Arboricultural Briefing Note - Offsite Byway Improvements

Site: LAND AT WARISH HALL FARM, NORTH OF JACK'S LANE, TAKELEY

Application reference: UTT/22/3126/FUL / S62A.2023/0016

8th June 2023

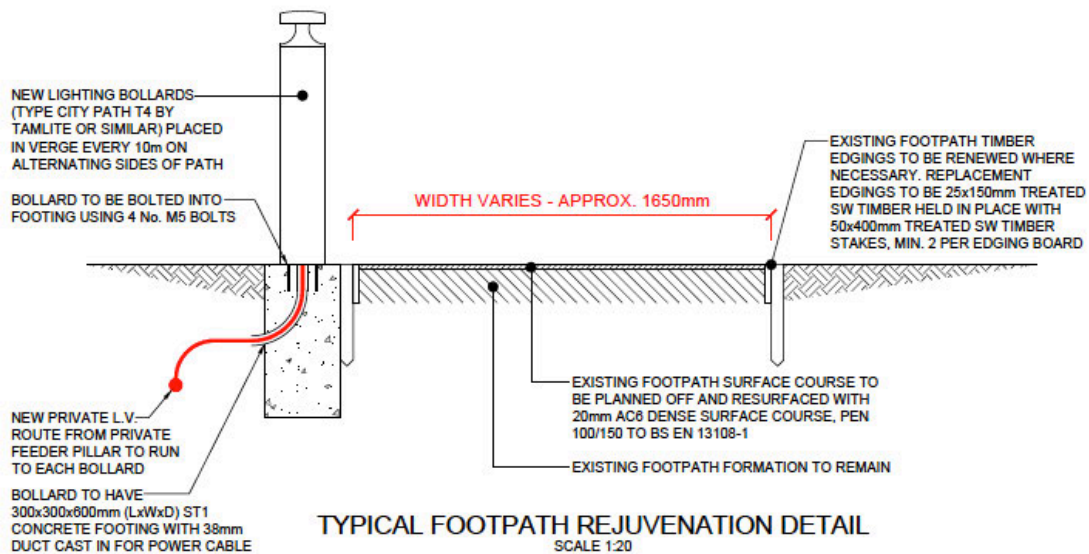
'Further to our comments on 24th May 2023, it has been brought to our attention that this application may require upgrades along the restricted Byway to the north of the site. From aerial photography, this currently appears to be lined with vegetation on both sides and is currently unsurfaced and so may be used by protected species. The Director for Highways and Transportation at Essex County Council has stated that the Byway is currently unsuitable to be used by proposed residents to access amenities from the application site. Since then it has been suggested it would need to be resurfaced and lit to be acceptable to be used as a main pedestrian link.

[The previously submitted ecology and arboriculture reports] did not assess these impacts along the Byway and so we are now not satisfied that there is sufficient ecological information available for determination of this application. It is recommended that an update or addendum is submitted assessing the ecological impacts by the proposed upgrades. It is also recommended that the proposals are discussed with an Arboricultural consultant'.

- 2.1 The existing Byway is well established. It is surfaced with well compacted soil/stone. The adjacent vegetation has been maintained in the past to provide clearance to the path.
- 2.2 The two images below show the current situation. The image on the left is a typical example of the path heading north from Jack's Lane along the eastern boundary of the site. The image on the right shows the path as it heads east along what is known as Jack's Lane to Burgattes Road.

- 2.3 The nature and quality of the vegetation either side of the paths is typical for what is expected along a path of this nature. There are no significant, high quality trees present close to the Byway. The existing compacted surfaces will likely have prevented or restricted any root growth beneath the path.
